BRUNSWICK STEAM ELECTRIC PLANT, UNIT NOS. 1 AND 2
DOCKET NOS. 50-325 AND 50-324/LICENSE NOS. DPR-71 AND DPR-62
RESPONSE TO REQUEST FOR ADDITIONAL INFORMATION - REQUEST FOR
LICENSE AMENDMENTS TO ADOPT ALTERNATIVE RADIOLOGICAL SOURCE
TERM (NRC TAC NOS. MB2570 AND MB2571)

Response to Request For Additional Information (RAI) AST 5

FIGURE 37-1
Control Building Ventilation System : Normal Flowpaths

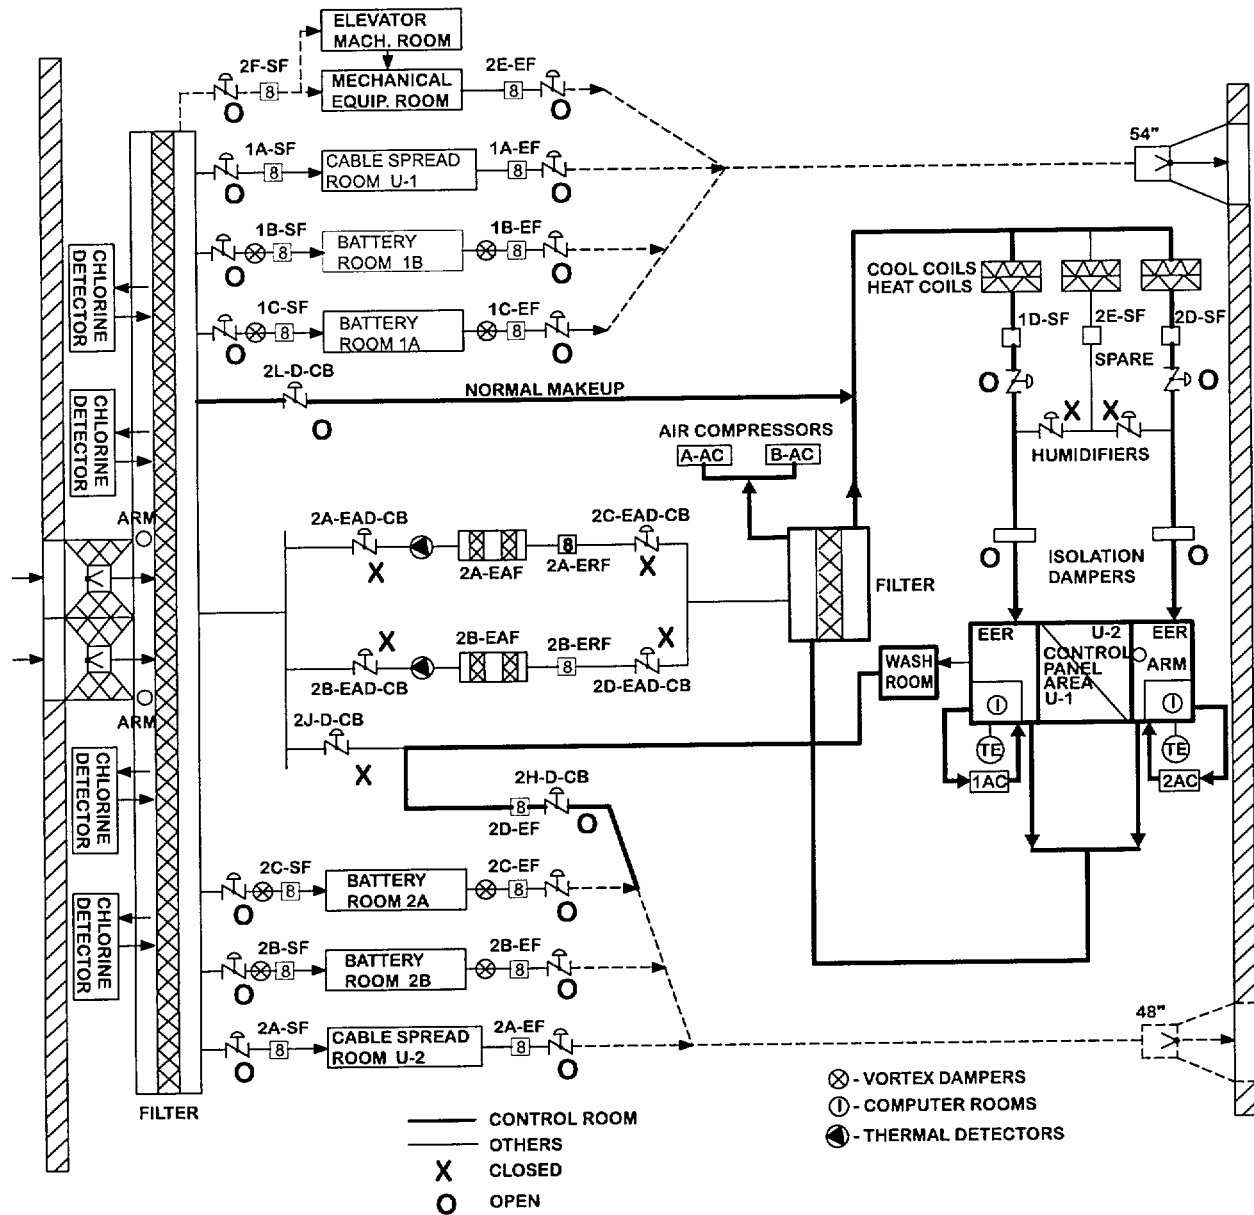
Provide a simplified schematic drawing of "Control Room Ventilation," including key valves and dampers.

The normal line-up for the Control Building Ventilation System is shown in Figure 37-1, "Control Building Ventilation System: Normal Flowpaths" of the system description, SD-37, provided as Enclosure 4. The emergency recirculation mode line-up (i.e., Control Room isolated) for the Control Building Ventilation System is shown in Figure 37-2, "Control Building Ventilation System: Detected High Rad/Fire" of the system description.
